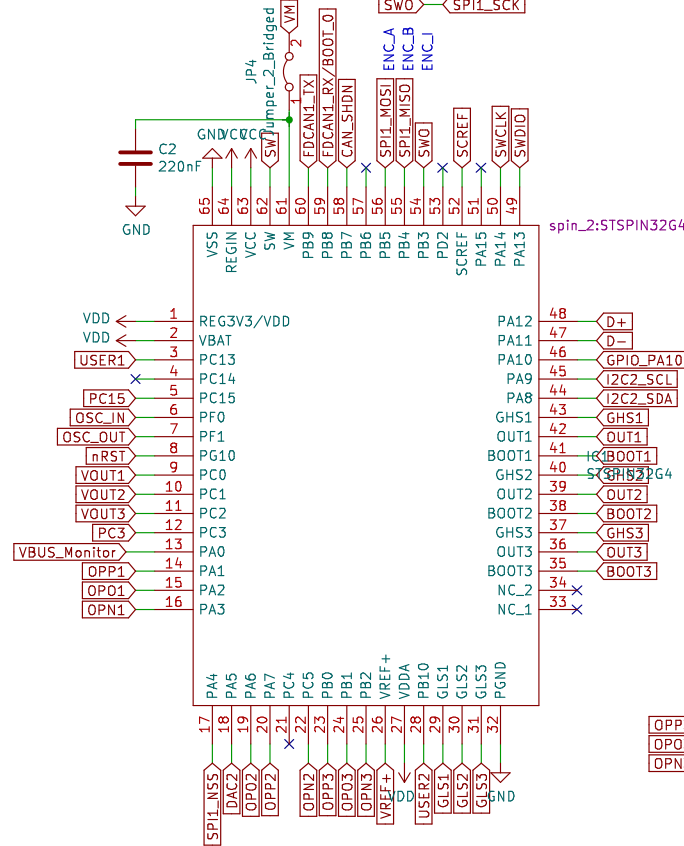
Crystal is 12mhz not 24mhz like in schematic maybe should update?

These caps (C8,C9) for VDA

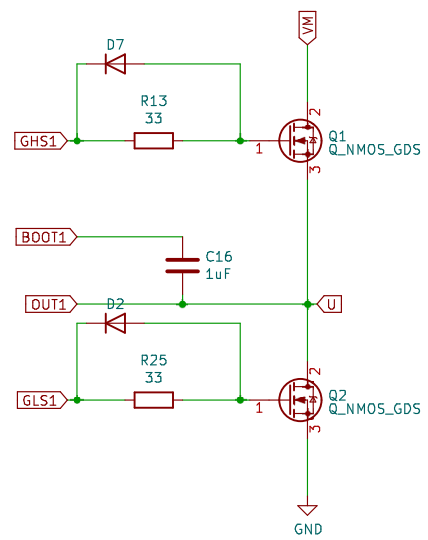
Have removed jumpers for space

Replace jumper with pass through

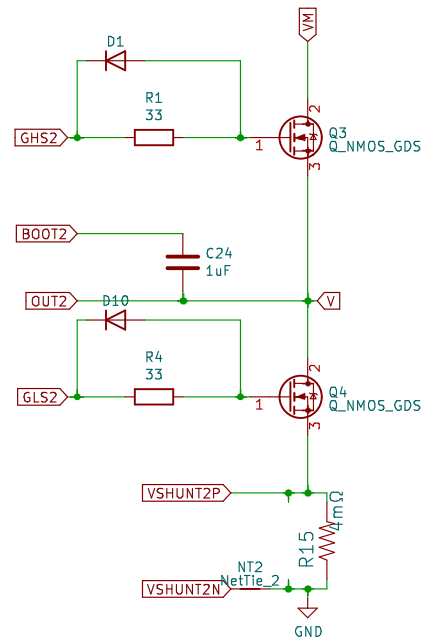
Replace jumper with pass through

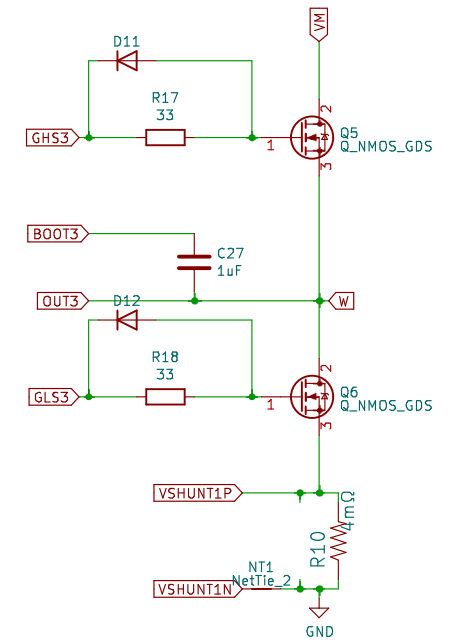
Replace jumper with pass through
